## **Annex G Insulating Fluids Subcommittee**

**March 27, 2019**

### G.2.1.1 C57.104 – IEEE Guide for the Interpretation of Gases Generated in Oil – Immersed Transformer (PAR Expiration: 12/31/19)

**C57.104 – IEEE Guide for the Interpretation of Gases Generated in Oil – Immersed Transformers**

**Excel line no. 3, BRG PC57.104 1<sup>st</sup> recirculation ballot responses and electronic vote comments to working group from Jim Thompson.**

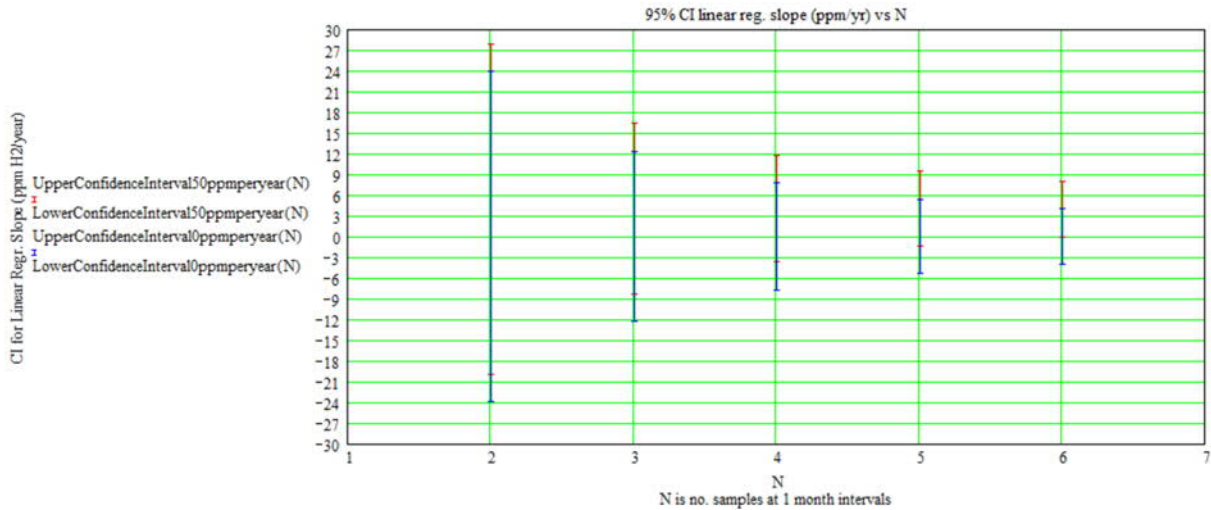
This issue was addressed by the BRG after the original ballot. It was rejected then, and should be rejected again.

1. There are other more widely used laboratory methods, such as ASTM D3612 Method C. *[Comment (JT.3/8/2019) Method has no stated precision statement for reproducibility. For repeatability it has only an “Interim Precision Statement for Repeatability for One Laboratory” reporting on twelve samples tested repeatedly. In that data, with the exception of CO<sub>2</sub>, the test method uncertainty is greater for each individual gas (repeatability interval is greater) than method B.]*

2. The values in Table 4 of Draft 6 are based upon an examination of 3 to 6 samples, which is a great improvement upon the 2008 edition which only requires a comparison of 2 oil samples. This change alone is a significant step towards addressing the challenge of measurement equipment accuracy/repeatability of results, which the 2008 edition did not address. *[Comment (JT.3/8/2019) The linear regression of three to six samples does not resolve the precision of the test method resulting in false rates due to the method variations for each sample test result. This is due to the fact that the table 4 rates (ppm/year) are so low that the signal to noise ratios for table 4 are under 1:2 (1/2 signal amplitude vs. 1 noise amplitude). The uncertainty inherent with the test methods, ASTM D3612 A, B and C, results in repeatability and reproducibility ppm variations that exceed the real changes that would be sought in Table 4. For example, look at just the table 4 value for variation of 50 ppm/year H<sub>2</sub> over a period of four months. The method B repeatability standard deviation is (0.17/1.96)\*(200 ppm) for a 200 ppm H<sub>2</sub> start value. That gives 200 +17 and – 17 ppm for a 95% confidence interval for the first test. But the monthly rate sought is (50/12 ppm per month or 4.2 ppm per month).*

3. The proposed change is to "reintroduce the tables in C57.104-2008 to replace Table 4." Only Table 4 of C57.104-2008 pertains to dissolved gas generation rate, and that table only utilizes Total Dissolved Combustible Gases (TDCG) to assess severity of gassing. This proposal does not address the comment's concern, and in fact worsens the problem. TDCG masks the possible severity of the rate of individual gases generated in the oil, and being a summation of individual measurements, the accuracy/repeatability problem would be compounded, not lessened. TDCG also has the inconvenient that all gases have the same impact on the evaluation, so for example C<sub>2</sub>H<sub>2</sub> change is treated at the same level as CO. while in fact it should be of much more concern. *[Comment (JT.3/8/2019) The 2008 document tables would be enhanced by using the tables 1 and 2 in the draft as well as guidance for sample intervals for retesting based on individual gases as an annex.]*
